Preliminary & Final Drainage Report

Sanctuary of Peace Residential Community

Project Number 61087

PCD Proj # PUDSP-019-002

PROPOSED DRAINAGE MAP

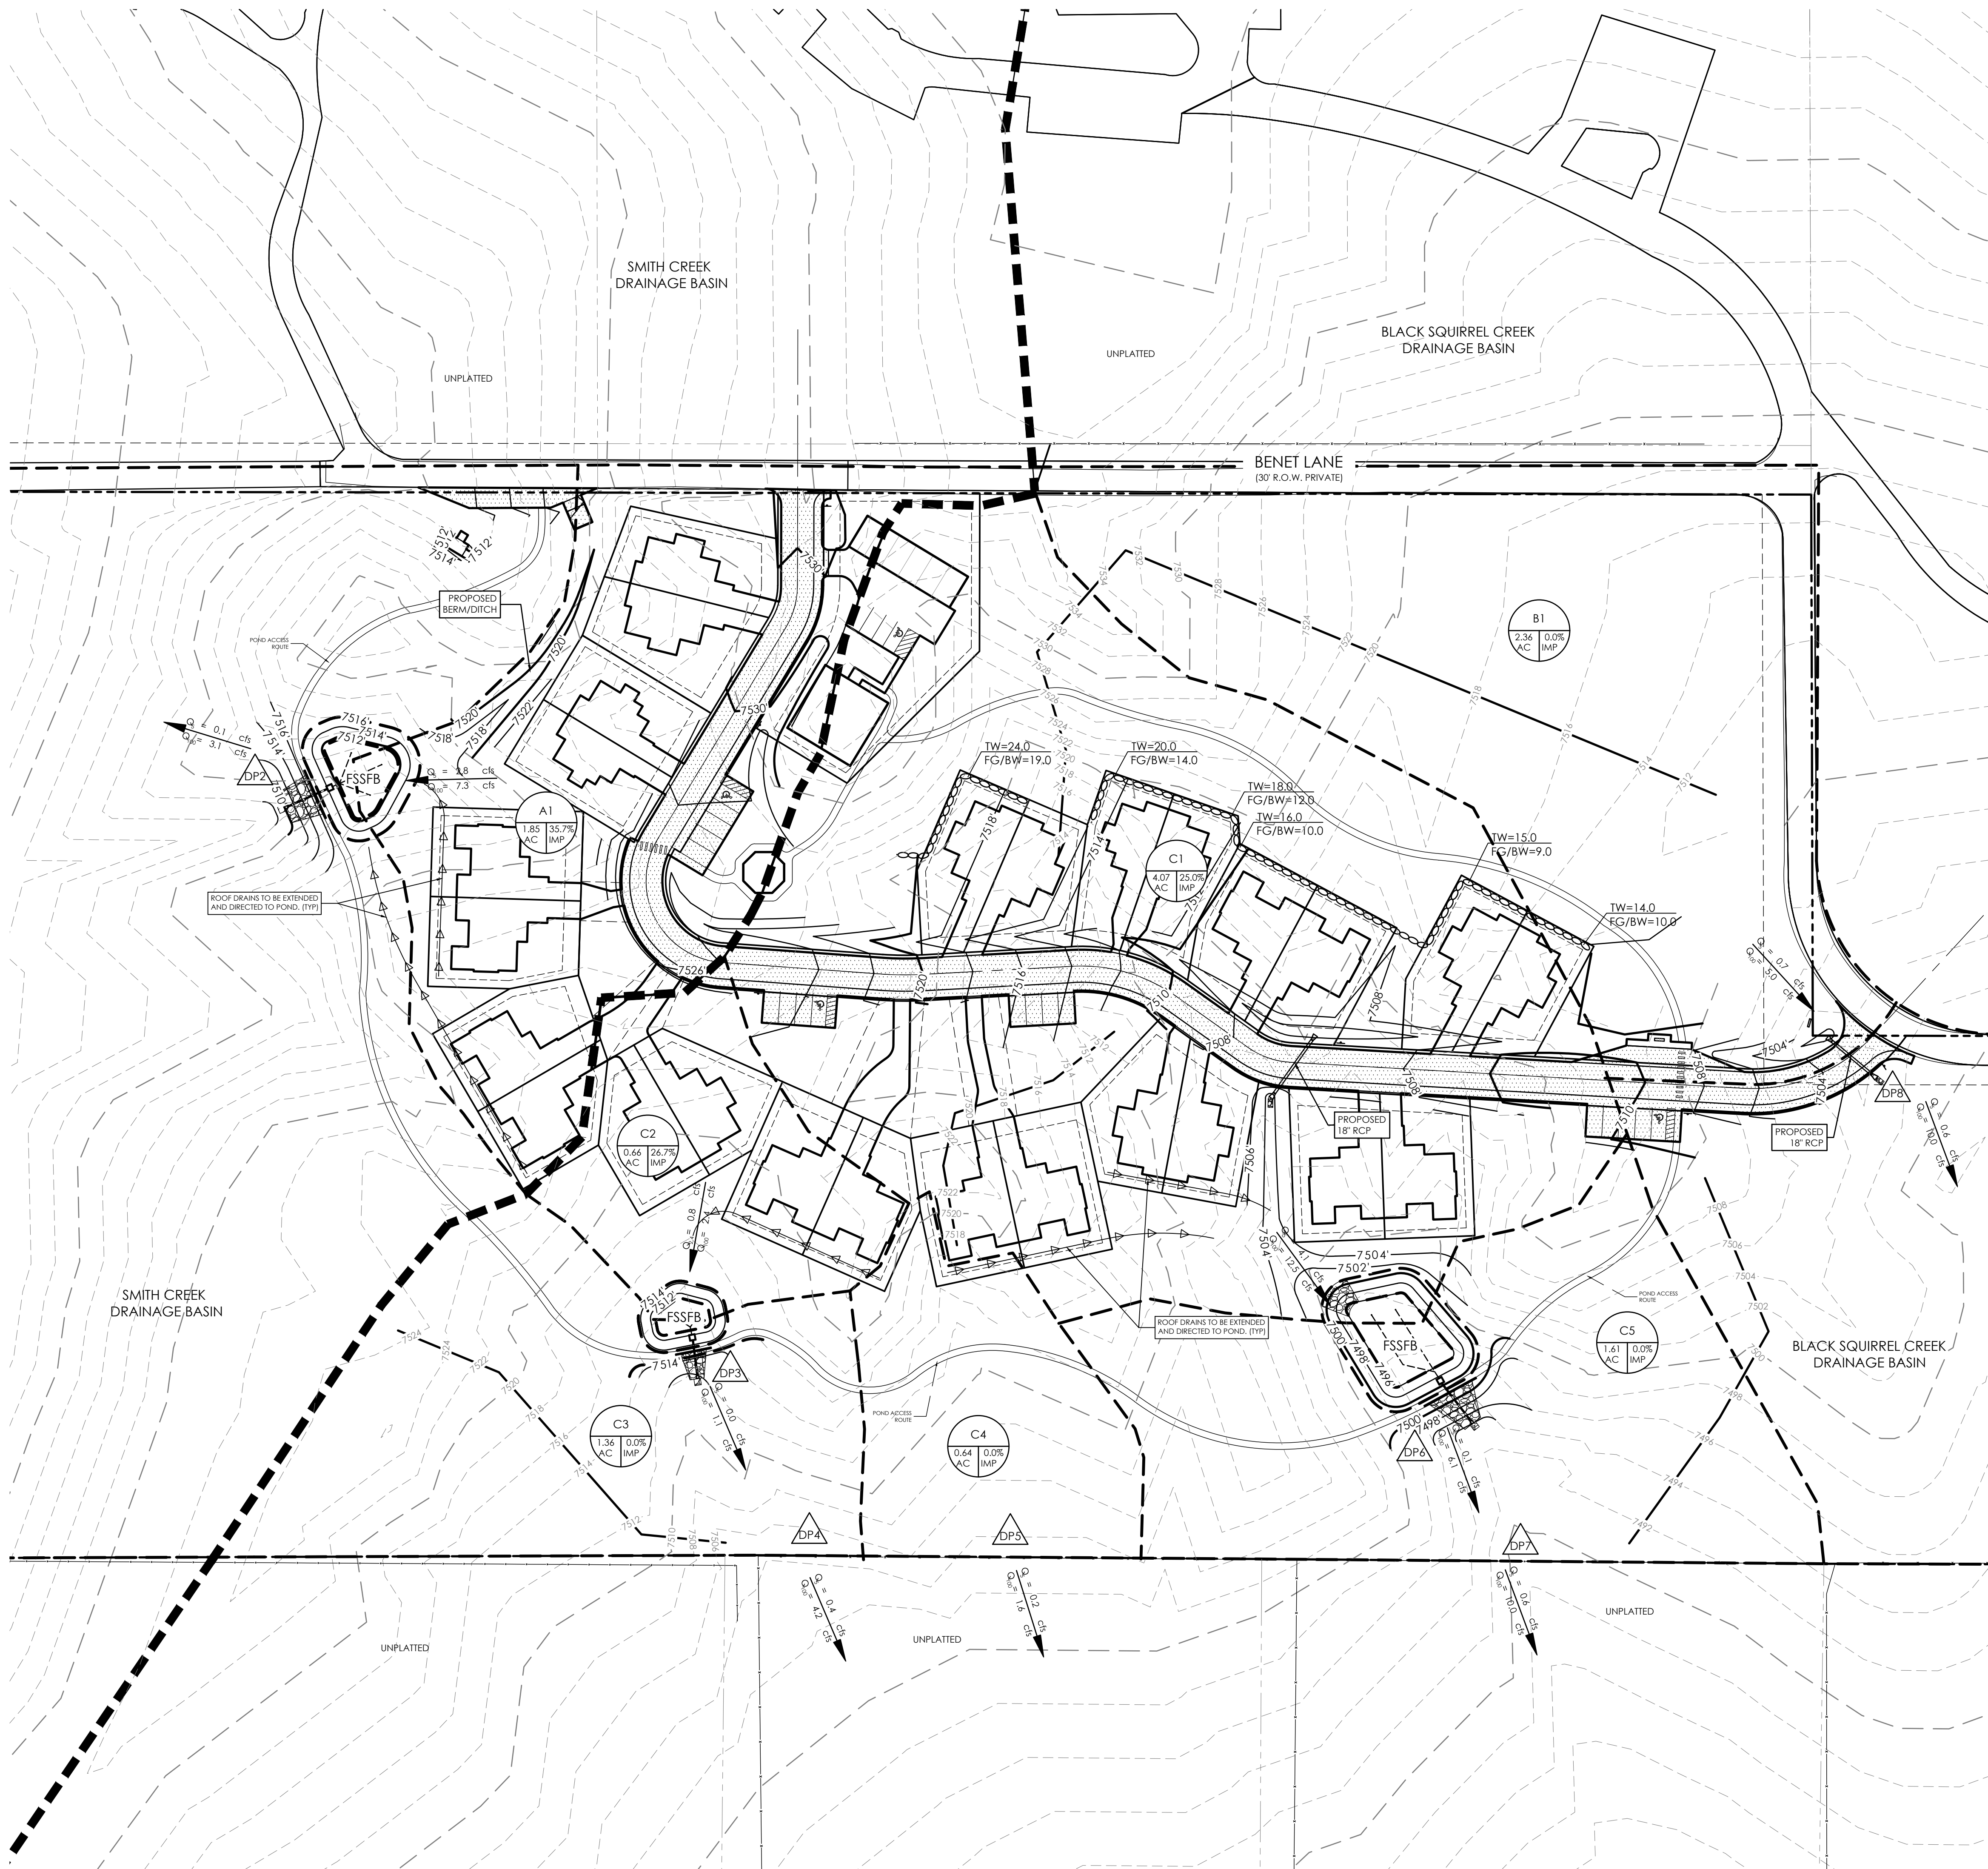
Please verify/revise the calculated flow at this design point as it is much larger than the existing conditions flow (19cfs/100.6 cfs) at this DP. Please provide any changes to this report in a separate addendum. A comment has also been provided on your calculation for this DP (pg 58 of 84)
